NUMBER: 08-001-08 REV. A

Long Engine Crank Time And/Or MIL Illumination Due To DTC P0340 / P0344

This bulletin involves the reprogramming of the PCM and the possible replacement of the engine camshaft sensor.

2008 (JK) Wrangler

Fig. 1 A CAMSHAFT SENSOR EXAMPLE

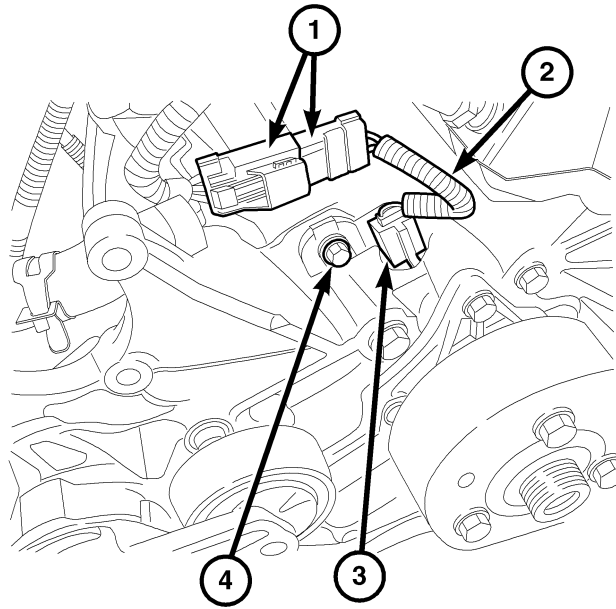
1. Disconnect and isolate the negative battery cable from the battery.
2. Disconnect the camshaft sensor electrical connector ([Fig. 1](#)).
3. Clean the area around the camshaft sensor and bore.
4. Loosen the camshaft sensor mounting bolt.
5. Remove the camshaft sensor from engine with a pulling and rotating motion.
6. Verify that the old O-ring on the camshaft sensor was removed with the old camshaft sensor.
7. Apply a couple of drops of engine oil to the new camshaft sensor O-ring.

NOTE: Verify that the paper spacer (orange in color normally) is in position at the end / tip of the camshaft sensor p/n 05149078AC.

8. Install the new camshaft sensor to the engine and rotate into position.
9. Push the new camshaft sensor down until contact is made with the camshaft gear.
10. While holding the new camshaft sensor in position against the camshaft gear, tighten the camshaft mounting bolt. Tighten the bolt to 14 Nm (125 in. lbs.).
11. Connect the camshaft sensor lead to the engine harness connector.
12. Connect the negative battery cable to the battery.

Fig. 2 AUTHORIZED MODIFICATION LABEL

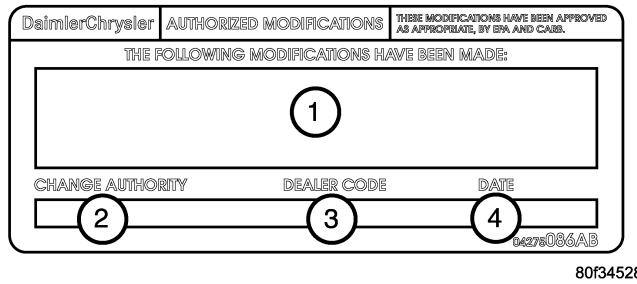
7. Type the necessary information on the "Authorized Modification Label" p/n 04275086AB and attach near the VECI label ([Fig. 2](#)).
